# PRELIMINARY DRAINAGE REPORT

## Storyrock Phase 1B

### Drainage Review Memorandum

**Re:** Storyrock - Phase 1B  
Case number: 5-PP-2016 #2

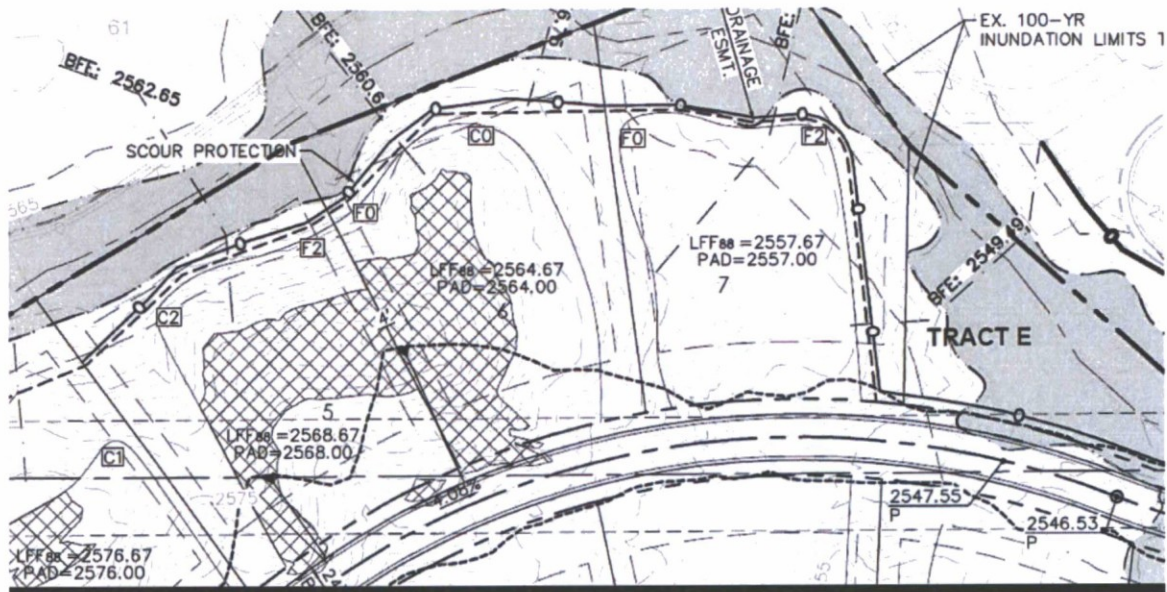
- a. **COS 1<sup>st</sup> Review:** Existing contours should be labeled much more frequently so that the elevation of any existing contour within the development can easily be determined. At present, the bulk of the lots do not include any existing contour elevations within or near the lot.

**COS 2<sup>nd</sup> Review:** Additional labels are required. Please see grading and drainage plan screen capture below:

**KHA Response:** Existing contours labeled more frequently and indicate existing contour elevations near or within all lots.

**KHA 2<sup>nd</sup> Response:** Existing contours have been extensively labeled throughout the preliminary plat with this submittal.

**Grading & Drainage Plan – Lot 76 (Sheet 6 of 8):**

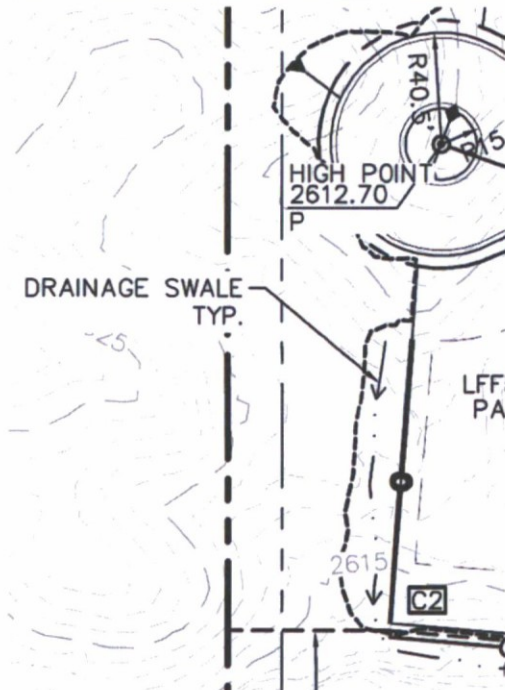
**COS 1<sup>st</sup> Review:** The presence of smaller washes will need to be clearly indicated on the plan via flow line and 100-year flow rate. For example, it is unclear if there is a moderately sized wash located west of Lot 76. Approximate 100-year floodplain limits should be shown and labeled on moderate to larger sized washes impacting proposed lots or other improvements.

**COS 2<sup>nd</sup> Review:** It appears that above response is to a comment (i) of Phase 2, referencing Lots 5 and 6. Please review and depict proposed flow routing for Lot 76 of Phase 1B. Depict all proposed flow re-routing and associated limits of disturbance. Limits of disturbance depicted on grading and drainage plan are not consistent with NAOS exhibit. Latest limits of disturbance should be reflected in NAOS area analysis tables and exhibits.

**KHA 2<sup>nd</sup> Response:** The grading limits adjacent to Lot 76 has been updated to appropriately depict the limits of disturbance and swale grading adjacent to the lot. The flow is not significant but has been accounted for in the limits of disturbance. A swale with flowline information is depicted on the preliminary plat.

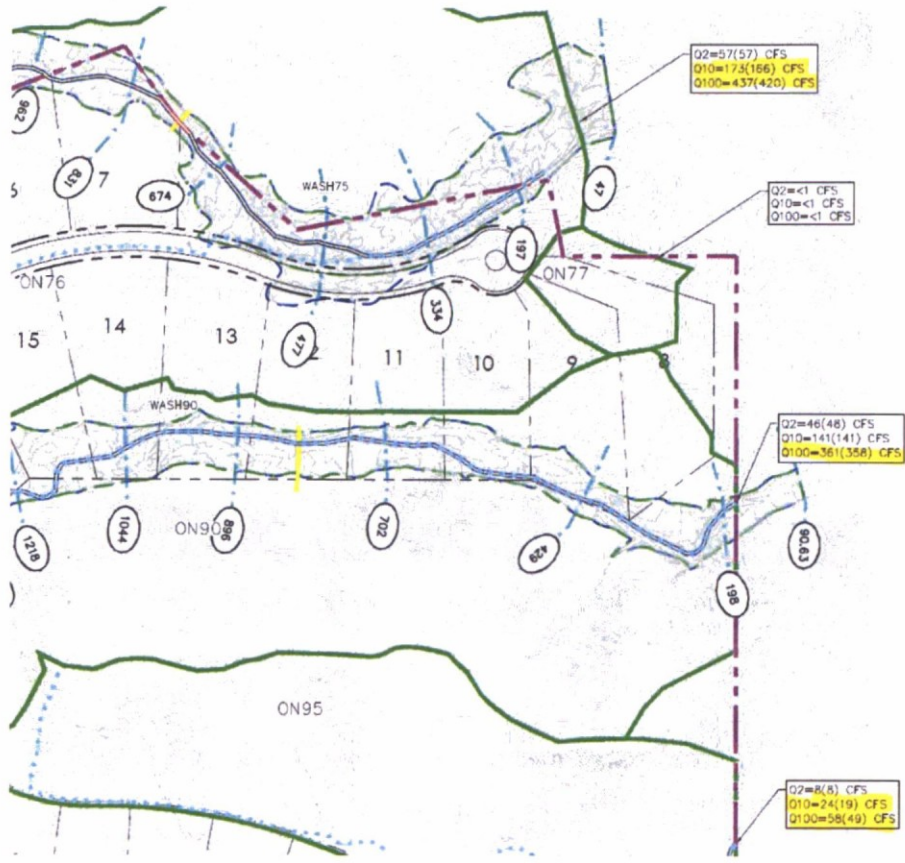
7. **COS 1<sup>st</sup> Review:** The preliminary drainage report will need to illustrate the project is meeting first flush requirements in general. The report should address whether proposed stormwater storage basins have been sized to meet the first flush requirement.

**COS 2<sup>nd</sup> Review:** Proposed alternative methods have to be approved by Stormwater Quality Coordinator (SQC). Any areas that are discharged directly to natural conveyance corridors have to be identified. Stormwater group is coordinating acceptable alternative methods with (SQC). Identify limits of disturbance required for implementation of alternative methods.

**KHA Response:** Detention basins proposed in the development meet first flush criteria. Some areas throughout the property propose to directly discharge into washes/channels that meander through the property. These areas have been identified in the drainage report and on the preliminary grading plan for alternative methods to stormwater pollution such as a stormceptor inlet structure. These areas are specifically proposed for alternative methods because the existing terrain and locations do not provide for adequate space or ability to grade a first flush basin to meet requirements. Furthermore, existing grades in these areas far exceed 5% slope and in some areas may require blasting. Stormceptor systems would be contained within the roadway tracts proposed and provide for an acceptable method to mitigate stormwater pollution exiting the property, however, additional alternatives may be proposed at final design and provided to staff for review and approval.

**KHA 2<sup>nd</sup> Response:** The alternative method proposed in various locations within the project are identified on the preliminary plat and discussed further in the drainage report. The areas shown are specifically proposed for alternative methods because the existing terrain and locations do not provide for adequate space or ability to grade a first flush basin.

As discussed with the City on April 12, a spillway and dissipation basin is an acceptable method by the Stormwater Quality Coordinator (SQC) to capture sedimentation and potential contaminants from street runoff in the areas constrained throughout the project. As requested, a detail has been provided with the Preliminary Plat and a discussion for the basin pool dimensions and have been provided in the drainage report.

Figure 4. Proposed Drainage Condition.

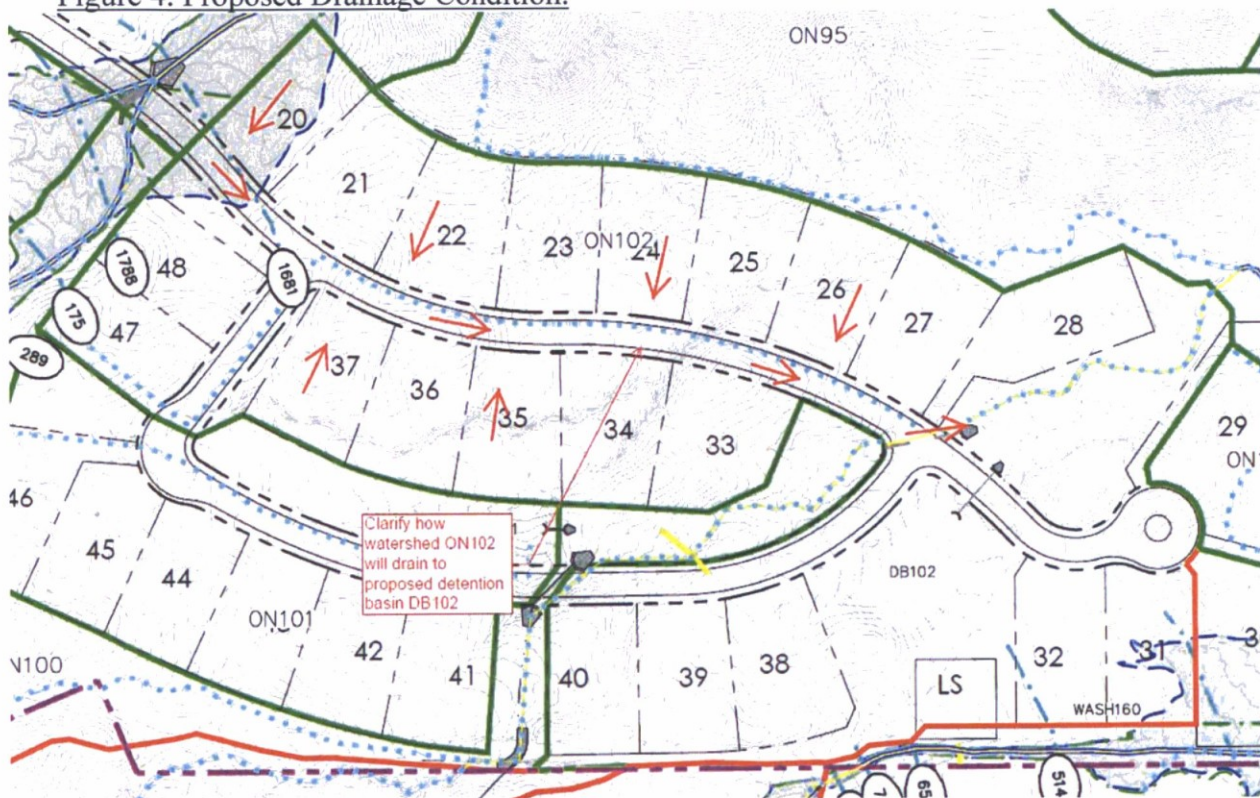
17. **COS 1<sup>st</sup> Review:** Provide sufficient level of information to demonstrate how proposed on-site watersheds will be routed through stormwater detention facilities. Add flow direction arrows to Figure 4, Proposed Drainage Condition map to clearly demonstrate intended flow patterns. HEC-1 model proposes routing of most watersheds through detention facilities in effort to reduce post development peak flows. See sample watershed below, how are the two northerly lots draining to proposed detention basin? Preliminary Grading and Drainage plan (sheet 7 of 8) does not show flow interception and routing to the proposed detention basin, that is not consistent with HEC-1 analysis.

**KHA Response:** Figure 4 and preliminary grading plan have been updated to better show proposed routing of onsite flows.

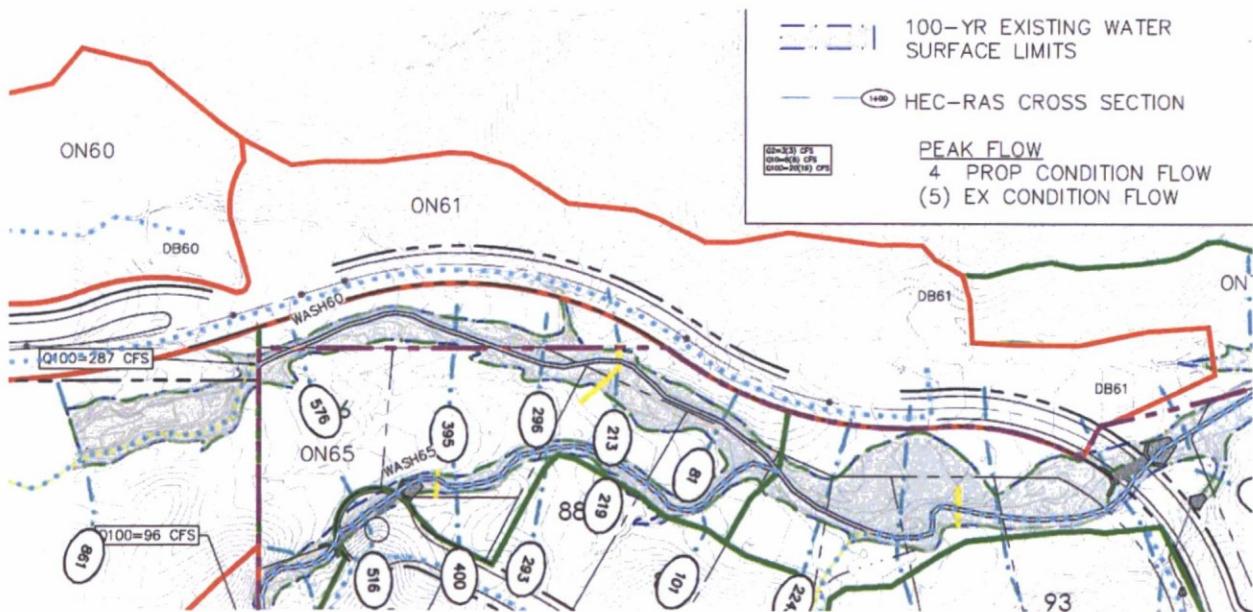
21. **COS 1<sup>st</sup> Review:** Provide sufficient level of analysis and discussion in the drainage report to demonstrate function and purpose of proposed stormwater storage basins

DB60 and DB61. Discuss sedimentation concerns due to upstream watershed being undeveloped. What instruments will be used to construct subject basin in event of two different ownerships between Phase 1A and Phase 1B? Use two basins ID's for DB61. Show inflow and outflow discharges. Submit grading and drainage plan for subject basins.

**COS 2<sup>nd</sup> Review:** Add a note to grading and drainage plan, and Figure 4 identifying that subject basins are to be constructed with the Ranch Gate Road improvements.

**KHA Response:** DB60 and DB61 are basins located within Phase 1A of the development, however, they are required with the construction of Ranch Gate Road improvements. Ranch Gate Road Improvements are being provided as part of a separate review and submittal (Master Plat Case) as discussed with the City previously. With the Master Plat submittal and review, all basin and roadway improvements to serve Phase 1A and 1B will be completed prior to parcel improvements. This is in specific response to ownership and phasing timing concerns for StoryRock.

DB60 and DB61 are sufficiently large to accommodate the drainage area of Ranch Gate Road and undeveloped Phase 1A area prior to Phase 1A being developed. The undeveloped area contributing to these basins prior to Phase 1A being developed is very small and without concentrated washes routing through the basins which provides for a very low probability for sedimentation concerns. It is important to note that all basins are to be maintained by the HOA in order to alleviate any sedimentation buildup that may occur.

**KHA 2<sup>nd</sup> Response:** Note has been added to the preliminary grading and drainage plan as well as Figure 4 of the drainage report.
